ADDENDUM NO. 1

August 3, 2023

Geiger House
2631 Gilbert Avenue
Cincinnati, OH 45206

Emboss Design (formerly PCA)
906 Monmouth Street
Newport, KY 41071

DRAWN BY DSD	CHECKED BY SSS
PROJECT NO.: 10041	
SCALE: AS NOTED	
DATE: 04-13-2023	
DRAWING TITLE PLUMBING FIRST FLOOR PLAN	
SHEET NO. P101

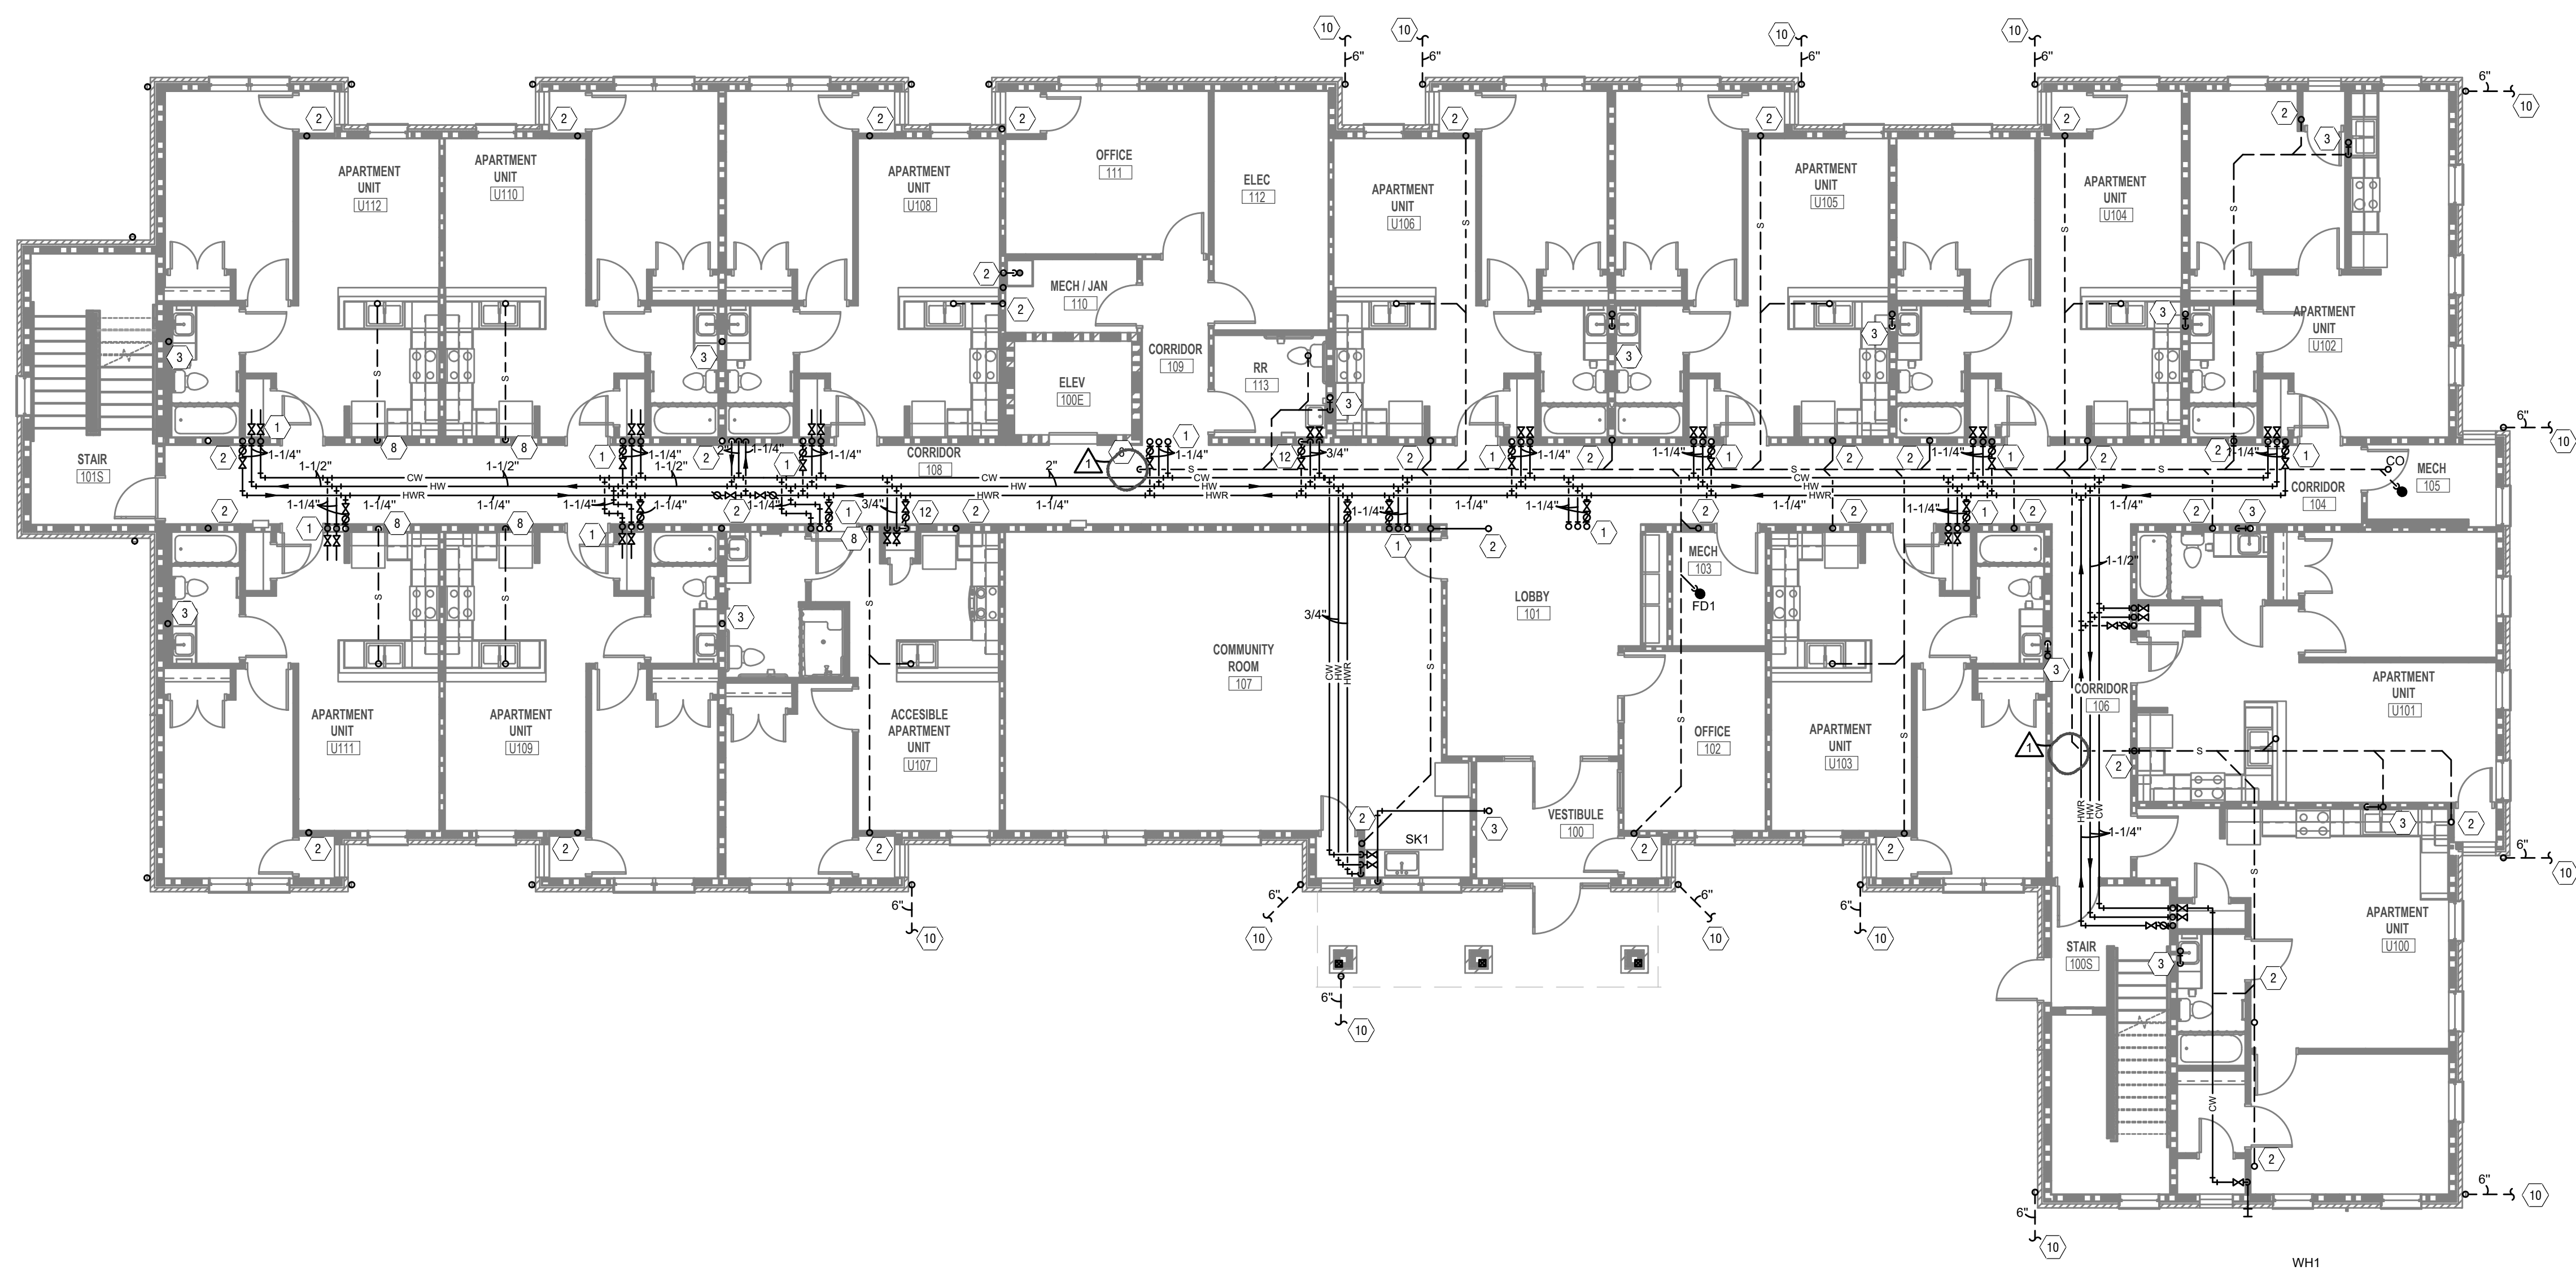
8. P101 PLUMBING FIRST FLOOR PLAN:

- Removed cleanouts in Corridor 106 and 108 floor in response to OHFA review comment

1
PLUMBING BASEMENT ISOMETRIC
 P301 NOT TO SCALE

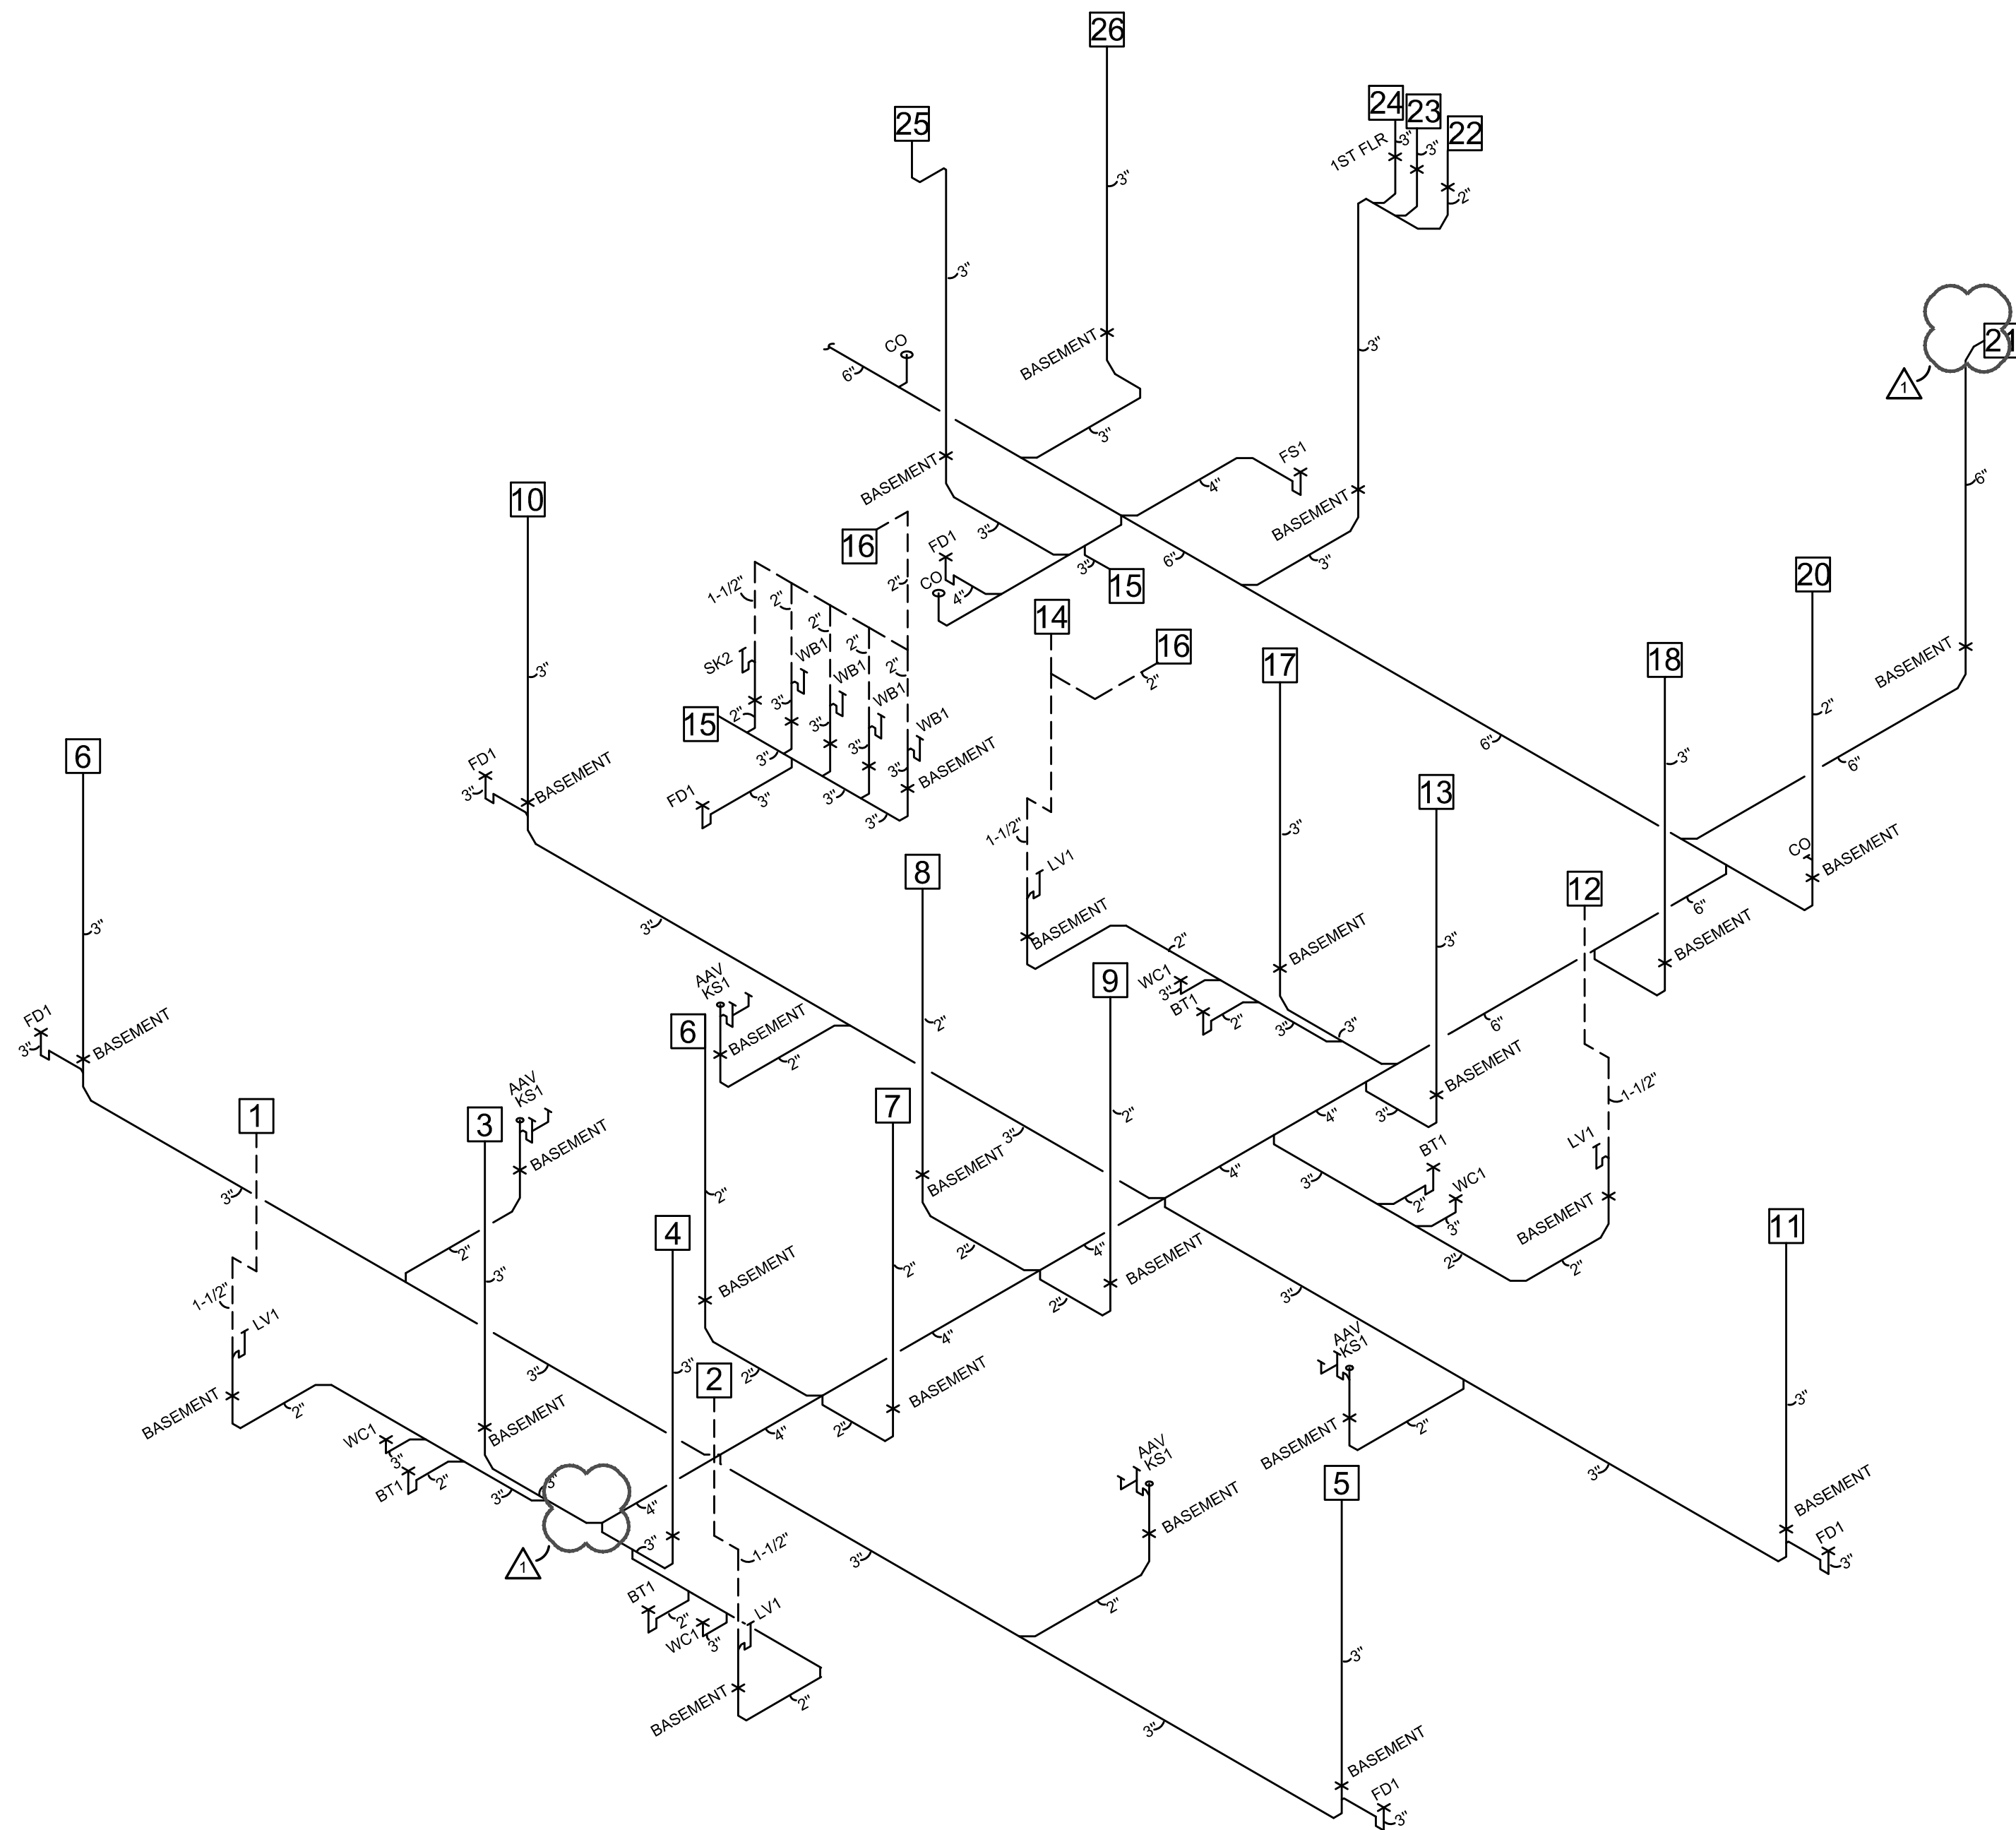
10. P301 PLUMBING DETAILS, SCHEDULES, AND ISOMETRIC:

- Removed floor cleanouts in response to OHFA review comment
